REVIEWED BY *[Signature]* PC 11052 PAGE 3  
 DATE: 2-16-90

REVIEWED BY *[Signature]* PC 11052 PAGE 4  
 DATE: 2-16-90

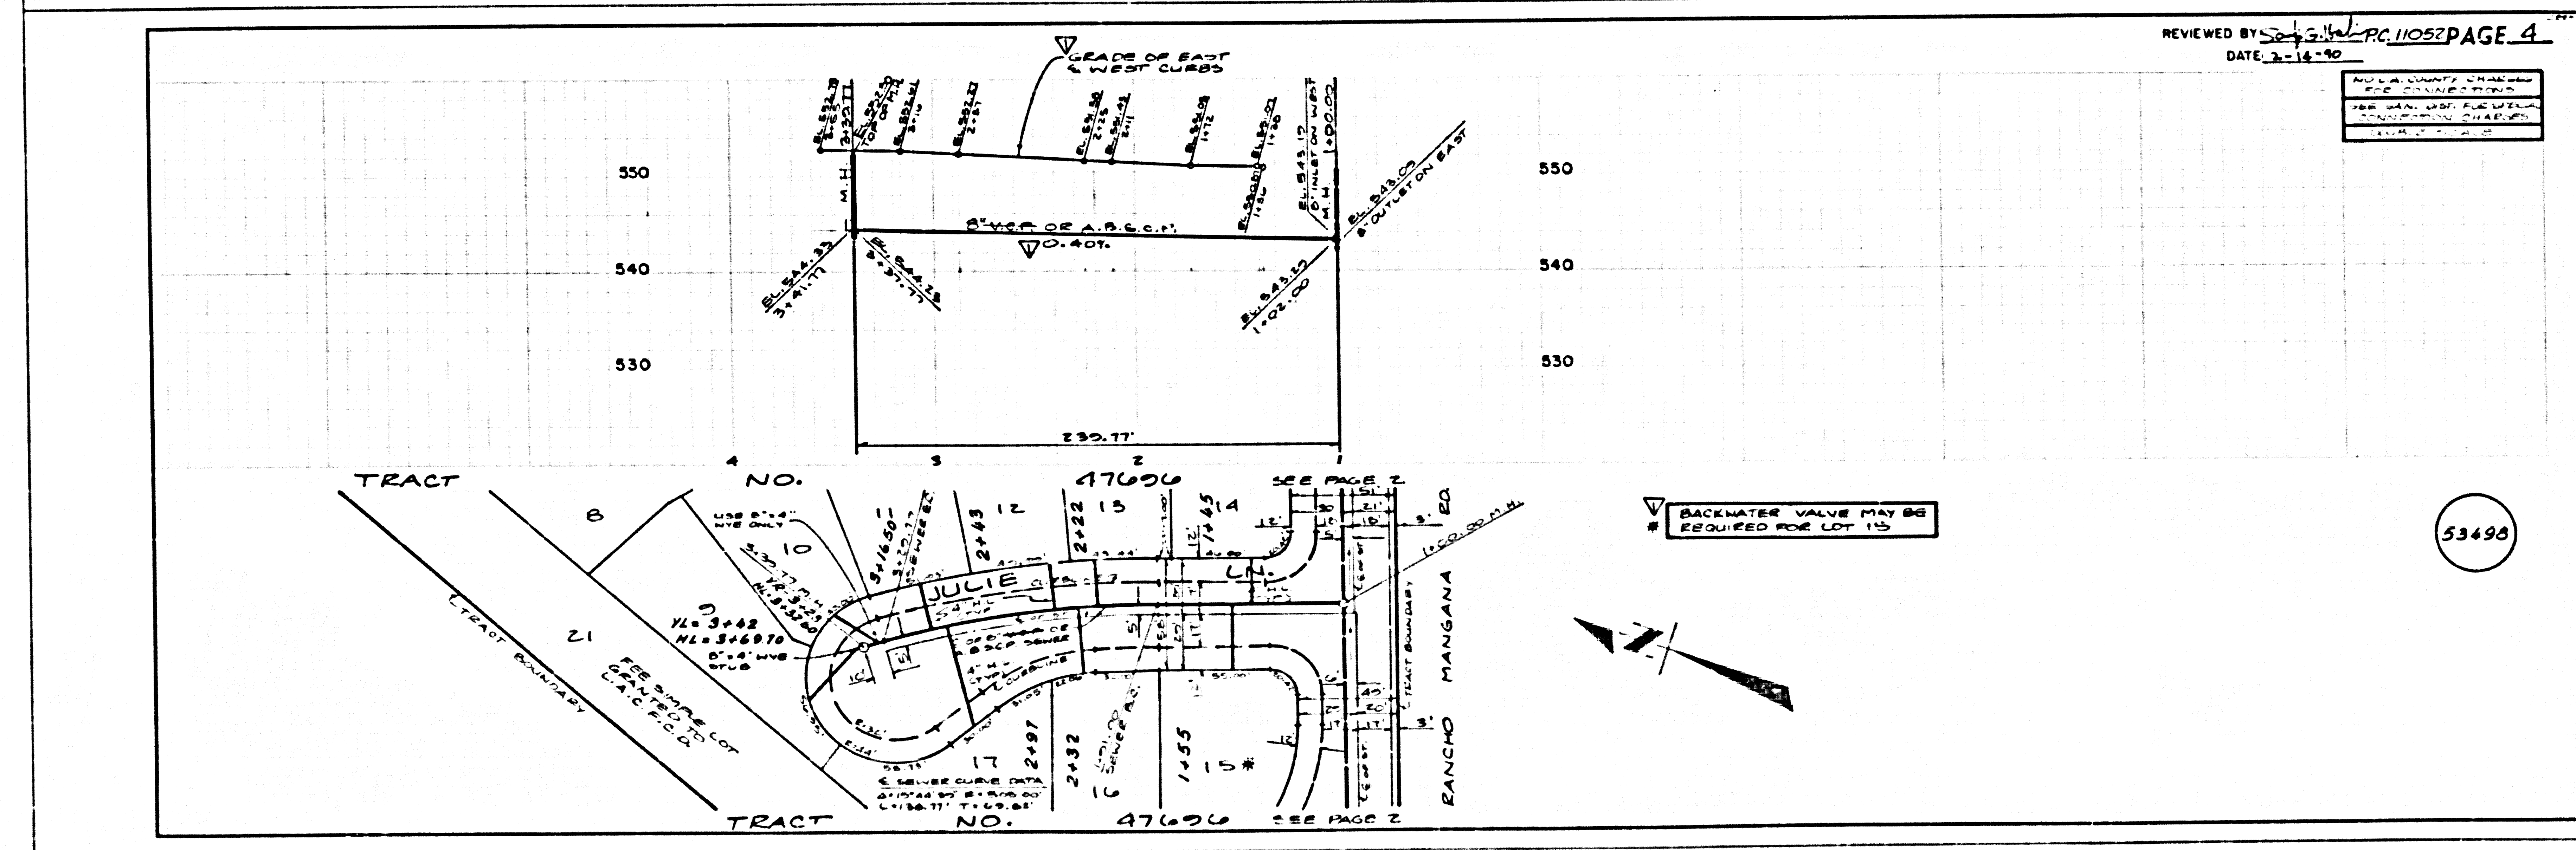
COLLECT CHARGES AS INDICATED  
 SEE SAN JOSE FOR SPECIAL CONNECTION CHARGES  
 PER A.C. 11052

BACKWATER VALVE MAY BE REQUIRED FOR LOTS 2 & 6

COLLECT CHARGES AS INDICATED  
 SEE SAN JOSE FOR SPECIAL CONNECTION CHARGES  
 PER A.C. 11052

BACKWATER VALVE MAY BE REQUIRED FOR LOT 15
